**KNOXVILLE HISTORIC ZONING COMMISSION
STAFF REPORT - CERTIFICATE OF APPROPRIATENESS APPLICATION**

PROPERTY ADDRESS: 1104 Luttrell St 37917

FILE NO.: 7-O-18-HZ

LEVEL OF WORK: Level II. Painting masonry

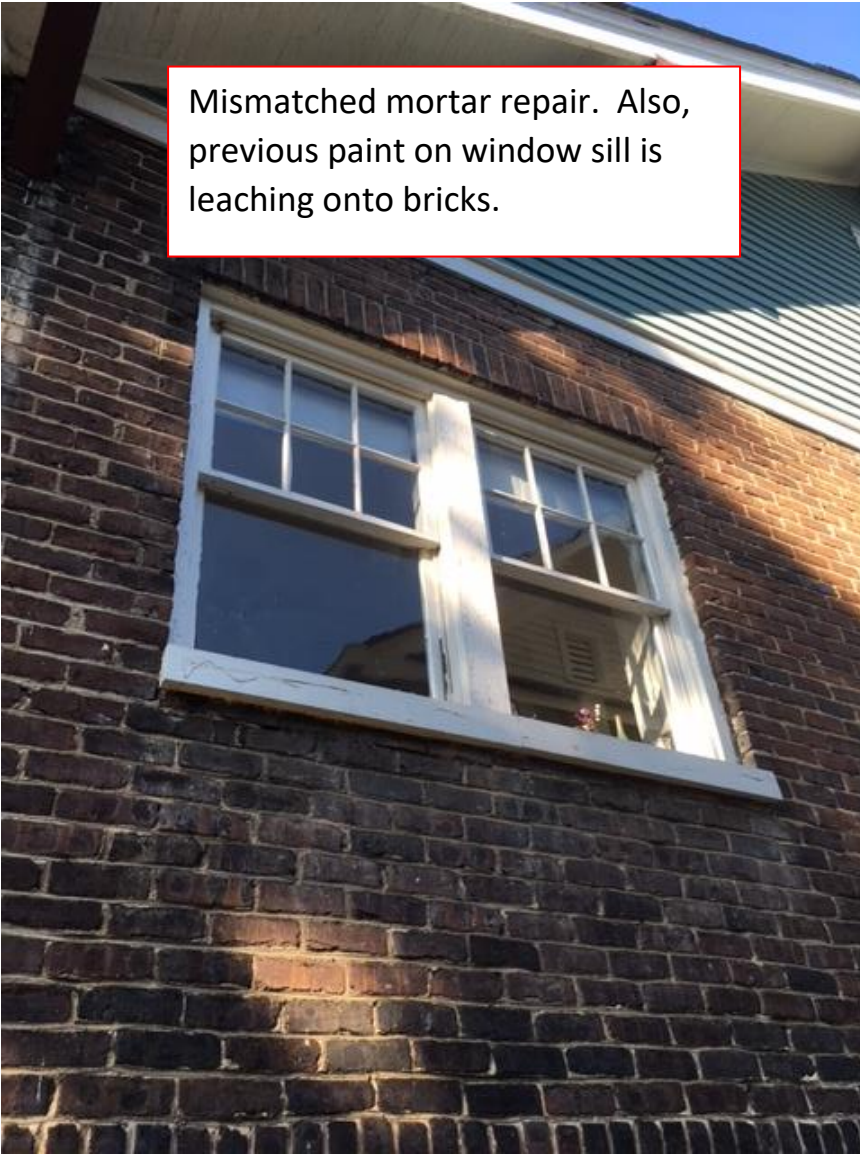
Front view from slightly north.

Front view from slightly south.

Mismatched mortar repair. Also, previous paint on window sill is leaching onto bricks.

Mismatched mortar repair. Also, previous paint on window sill is leaching onto bricks.

Mismatched mortar repair. Also, previous paint on window sill is leaching onto bricks.

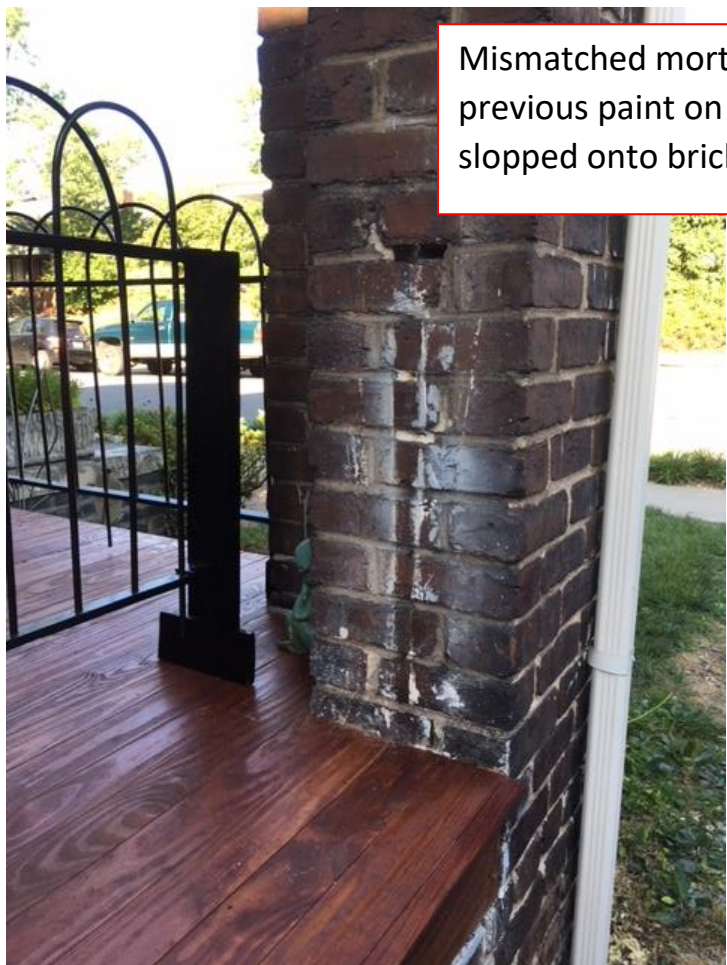
Mismatched mortar repair. Also, previous paint on window sill is leaching onto bricks.

Mismatched mortar repair. Also, previous paint on porch flooring and rails sloped onto bricks.

Mismatched mortar repair. Also, previous paint on porch rails sloped onto brick.

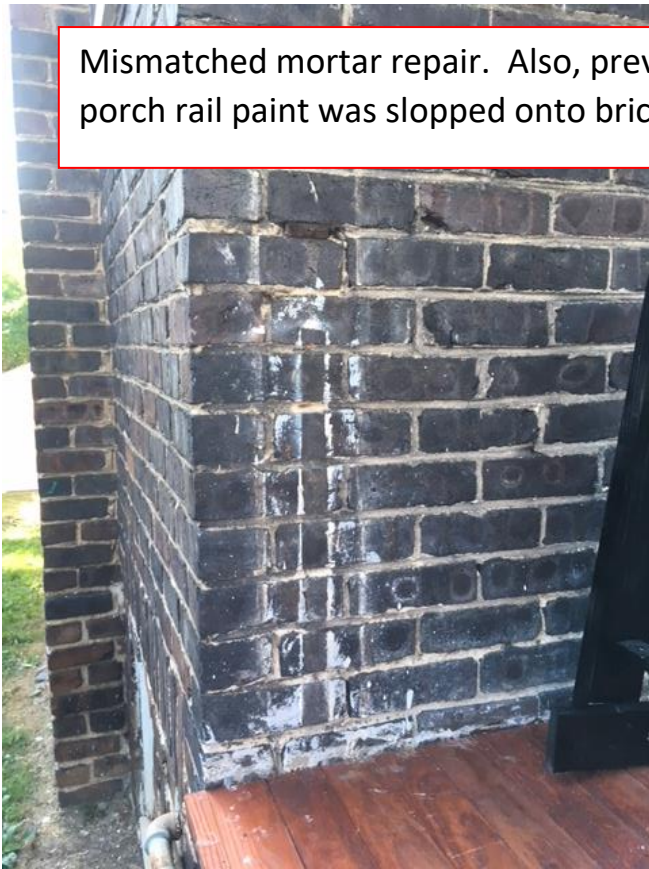
Mismatched mortar repair. Also, previous porch rail paint was sloped onto bricks.

Mismatched mortar repair. Also, previous paint on gutters splashed onto bricks.

Mismatched mortar repair. Also, previous paint from porch floor was slopped onto bricks.

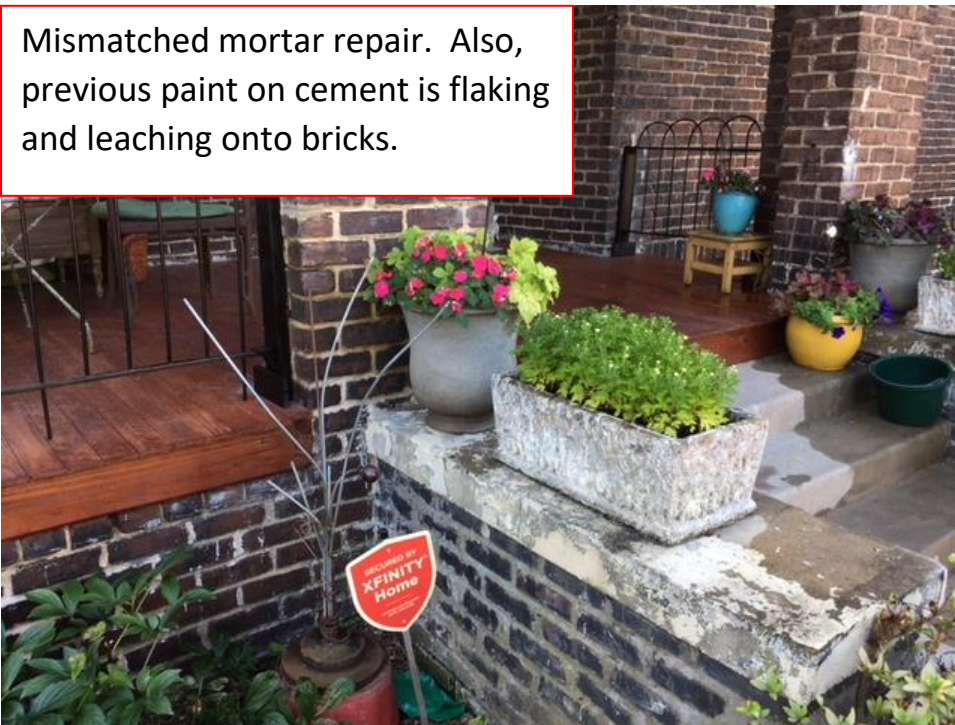
Mismatched mortar repair. Also, previous paint on cement is flaking and leaching onto bricks.

Mismatched mortar repair. Also, previous paint on cement is flaking and leaching onto bricks.

Previous paint from porch was slopped onto brick surface.

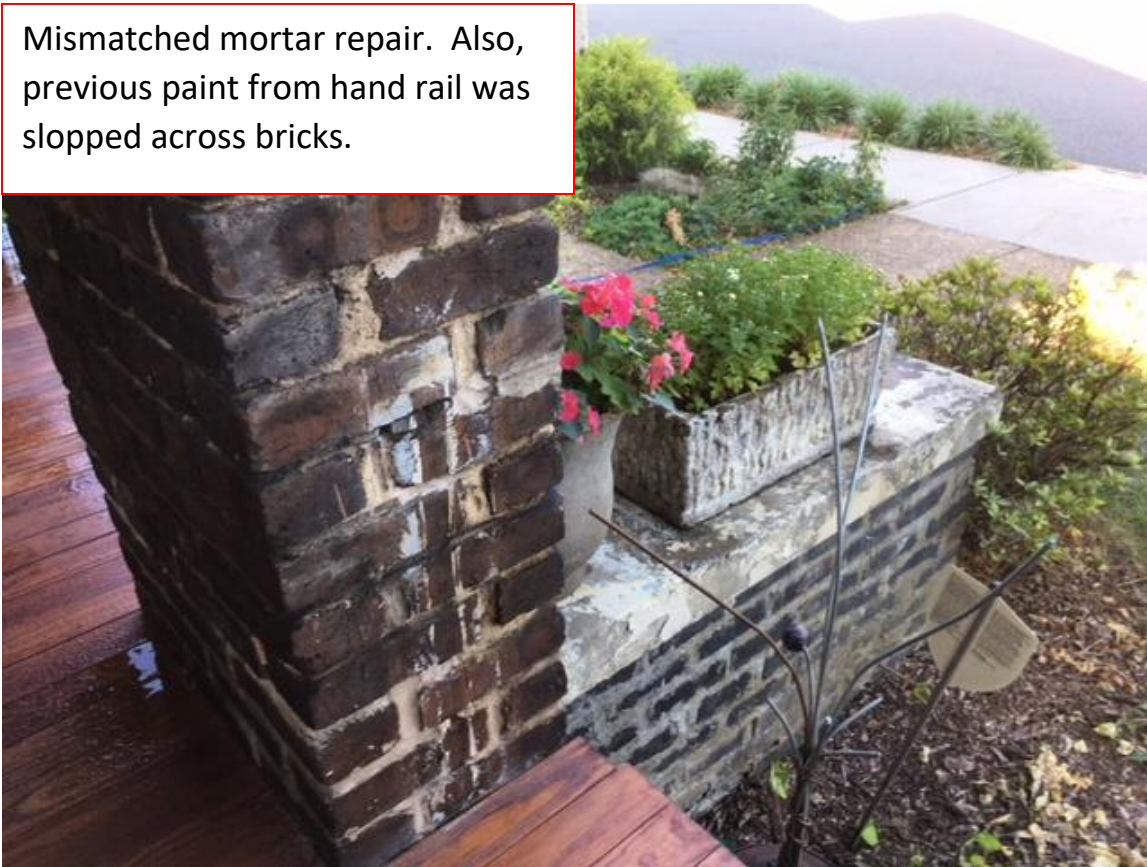
Mismatched mortar repair. Also, previous paint from hand rail was slopped across bricks.

Mismatched mortar repair. Also, previous paint from hand rail was slopped onto brick surfaces.

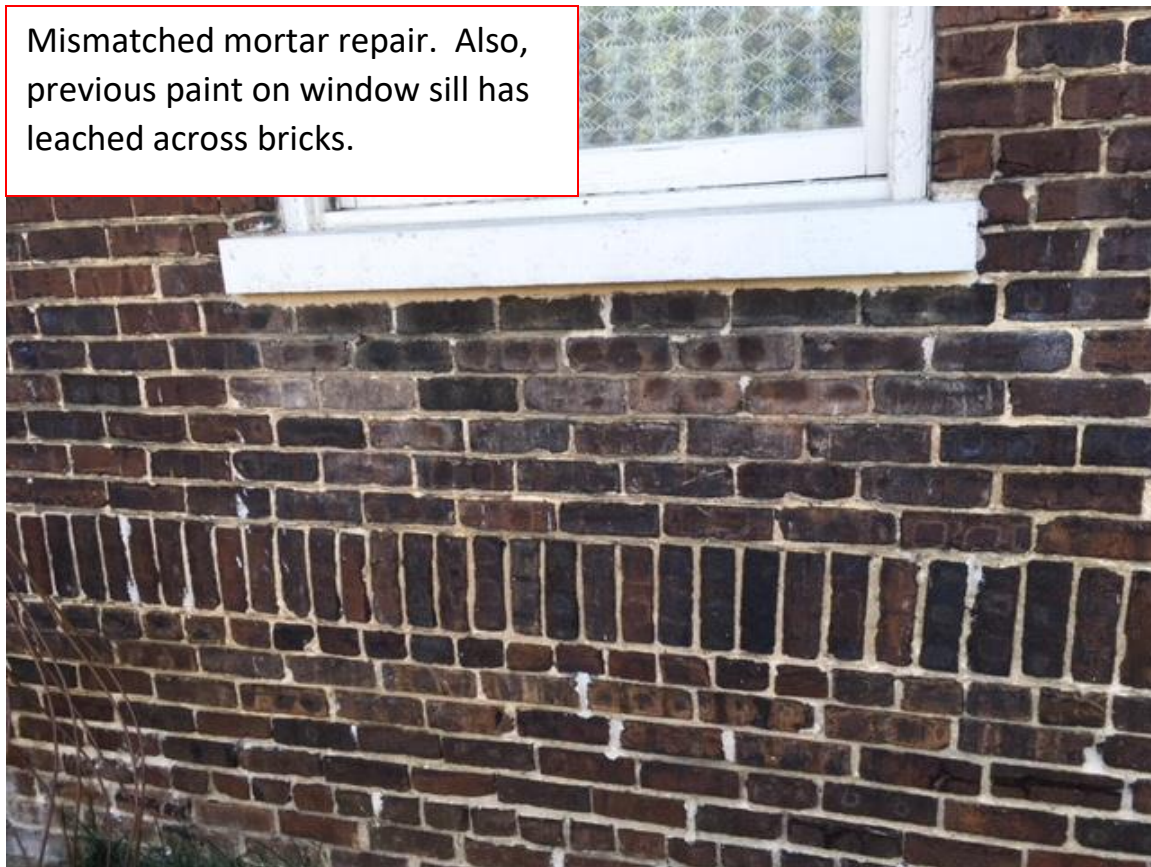
Mismatched mortar repair. Also, previous paint on window sill has leached across bricks.

Overall view of house's back side.

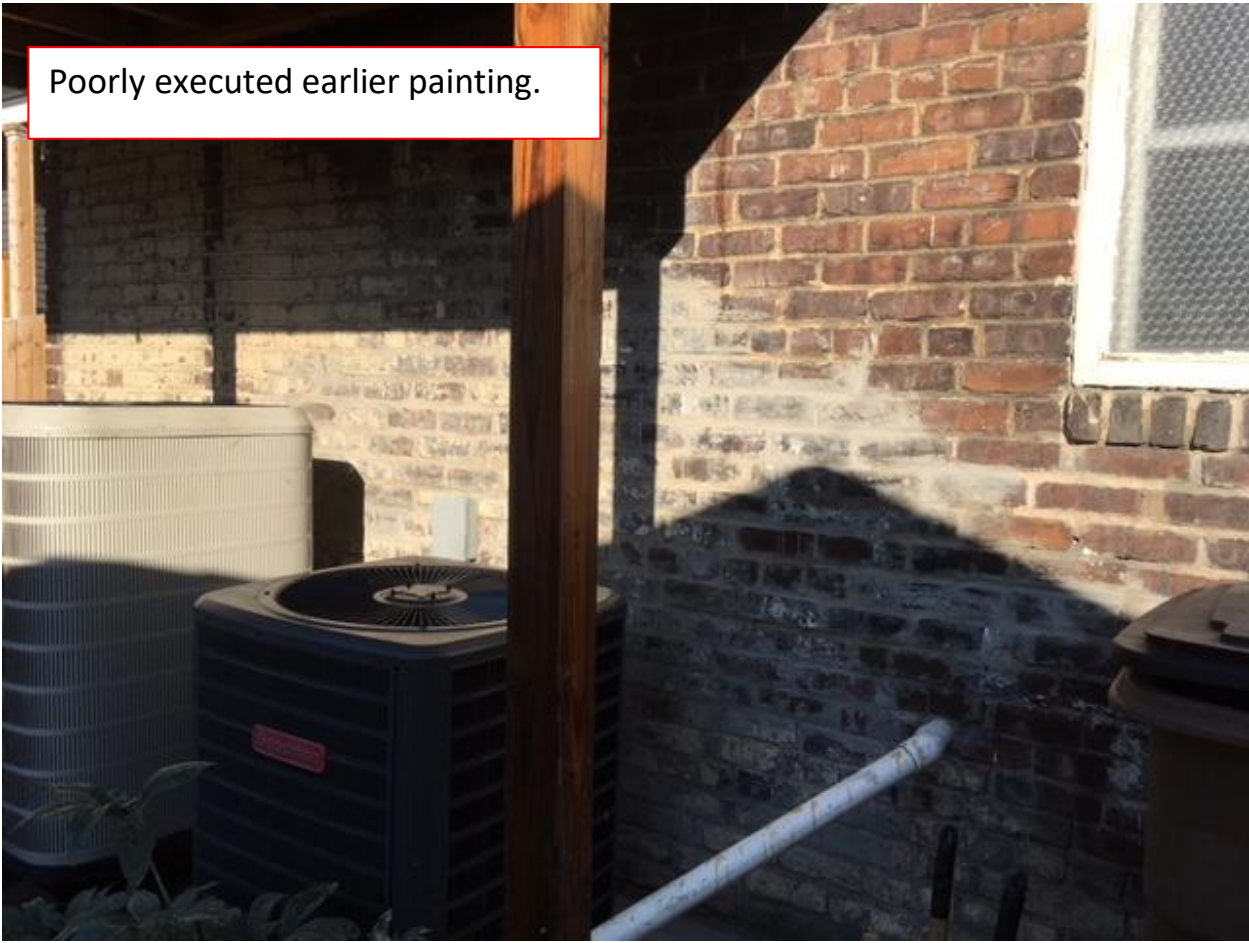
Poorly executed earlier painting.

Poorly executed earlier painting.

Poorly executed earlier painting.

Mismatched mortar repair.

Mismatched mortar repair.

Mismatched mortar repair, plus paint spots on brick from previous attempt to paint the gutter.

Mismatched mortar repair.

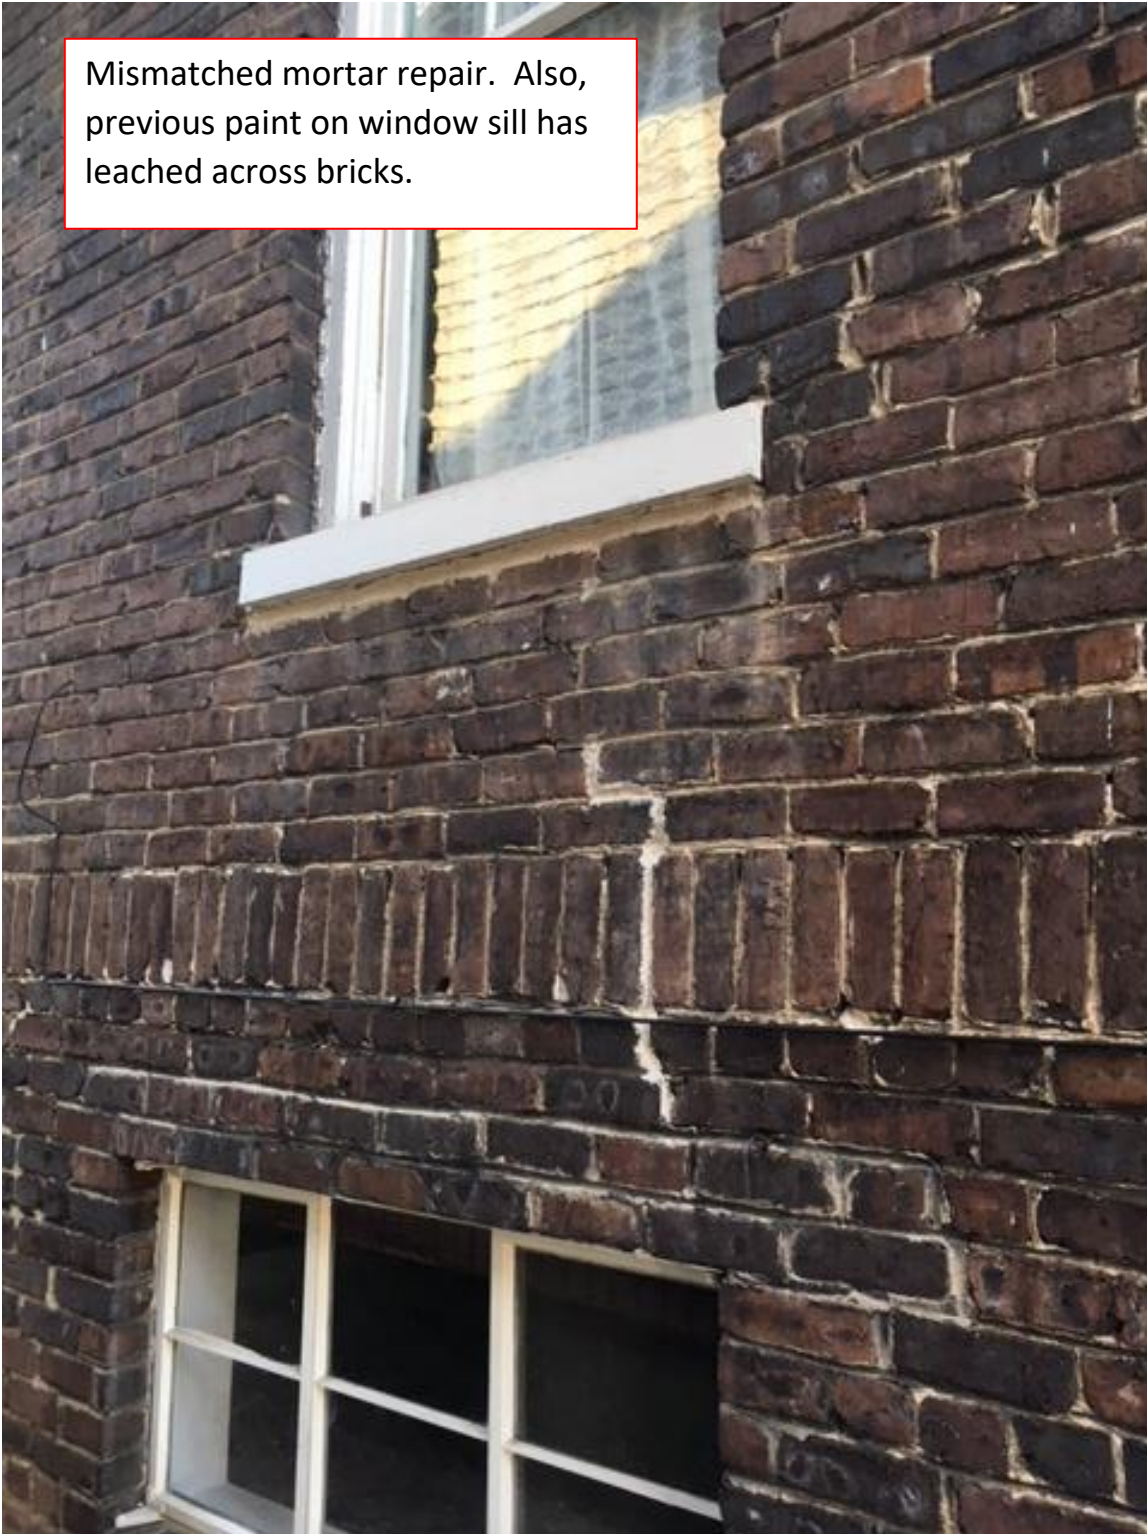
Mismatched mortar repair. Also, previous paint on window sill has leached across bricks.

Previous paint on window sill has leached across bricks.

Mismatched mortar repair. Also, previous paint on window sill has leached across bricks.

Mismatched mortar repair. Also, sloppy gutter painting splattered onto brick.

Mismatched mortar repair. Also, previous paint on window sill has leached across bricks.

Mismatched mortar repair.

Mismatched mortar repair.

Mismatched mortar repair. Also, previous paint on window sill has leached across bricks.
